IEEE802.3poep Study Group Revision of isolation requirements in IEEE802.3 clause 33.

San Francisco, July 2005

Block diagram of PSE and PI

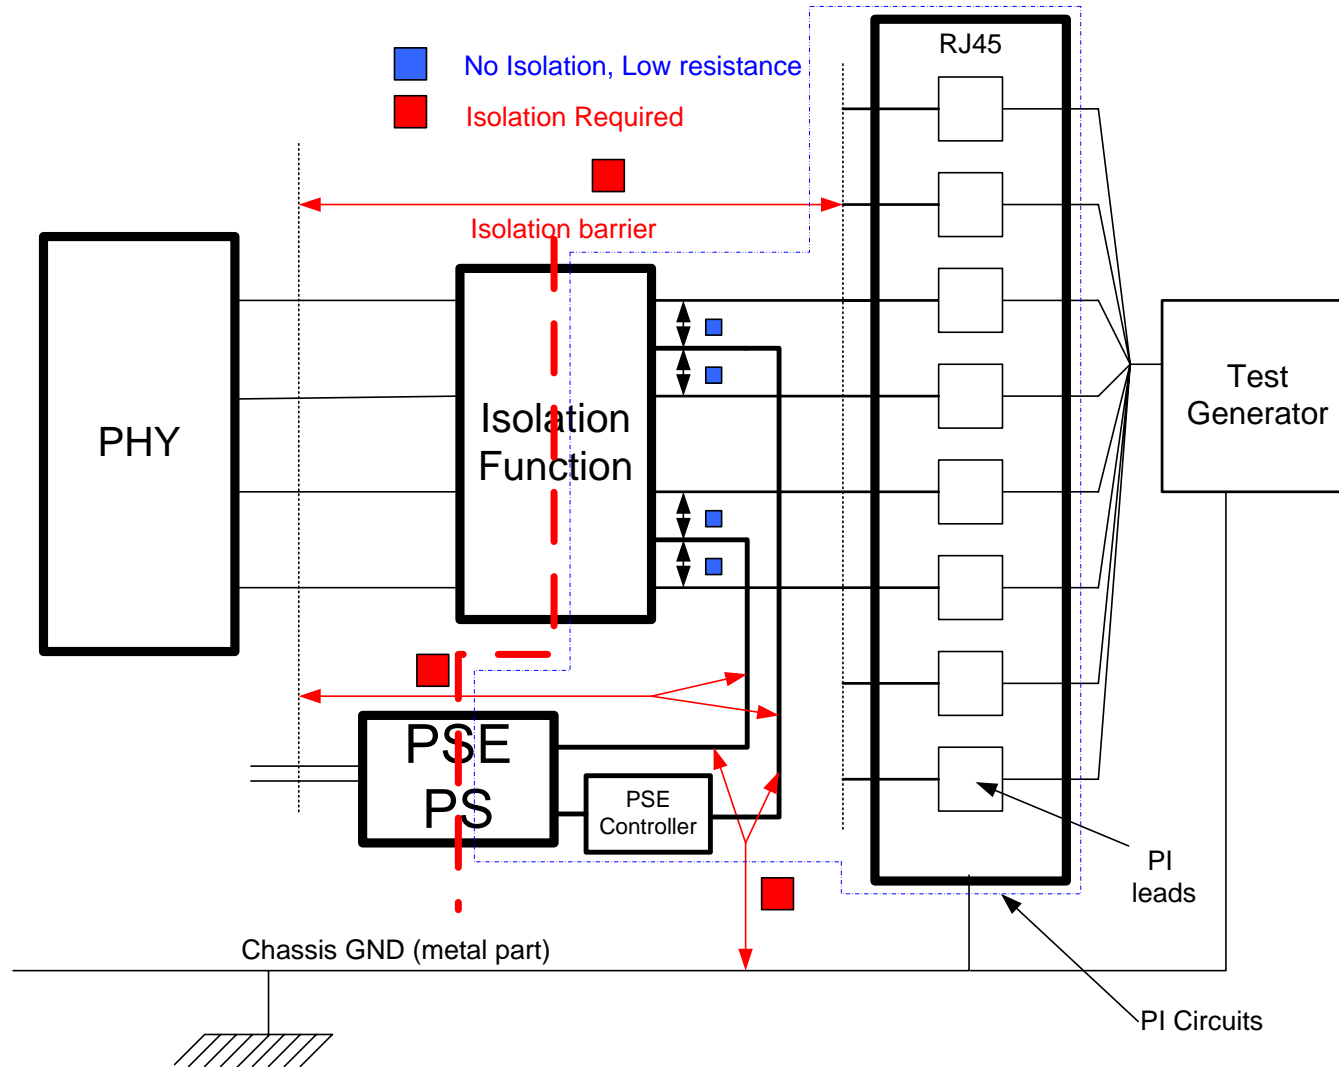
PSE isolation issue

- Statement from IEEE802.3af:

The PSE shall provide electrical isolation between the PI device circuits, including frame ground (if any), and all PI leads.

- What are the PI device circuits? Standard does not provide clear definition.
- Some people confuse PI devices and PSE and interpret that PSE should be isolated from PI which is obviously was not the intent.

Recommendation for PSE isolation requirements:

- Option 1 (Change text similar to PD requirements):
 - The PSE shall provide electrical isolation between
 - a) All PI leads and all **accessible** conductors, including frame ground
 - b) All PI leads and PHY
- Option2 (Text **similar** to 10BASE T standard):

PSE shall provide isolation between DTE Physical Layer circuits including frame ground and all **accessible** MDI leads.
